R08NM

# Lift Enable Interlock

# RECALL

**MODELS AFFECTED:** 2006-2009 Micro Bird with Options 31047-01 Switch Lift Enable or 31048-07 Wiring, Interlock.

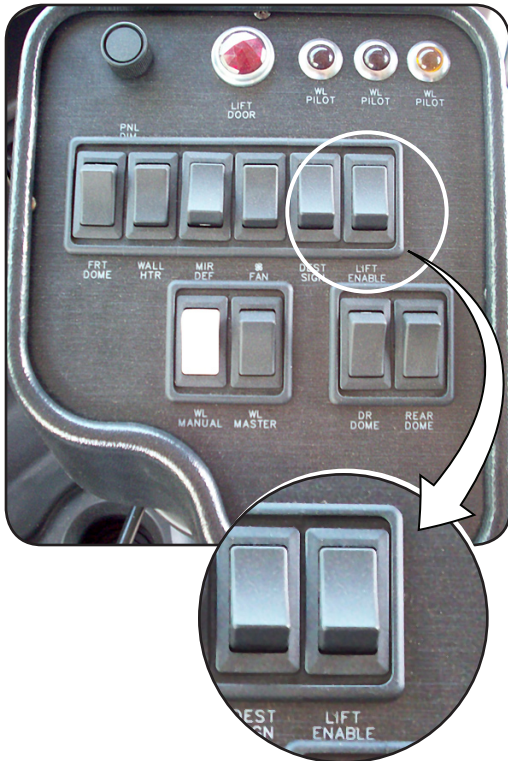
Lift enable switch can render wheelchair lift interlocks inoperative.

Remove lift enable switch, butt splice wires and install blank plug in former switch position.

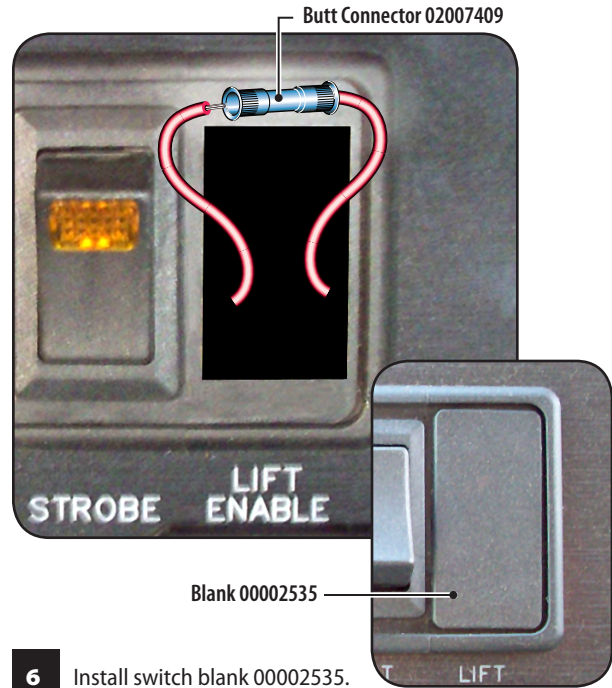
- 4 Cut the two wires as close as possible to electrical connectors,

- 5 Strip wires and install butt connector 02007409 connecting the two wires together. Push completed wiring back inside the panel.
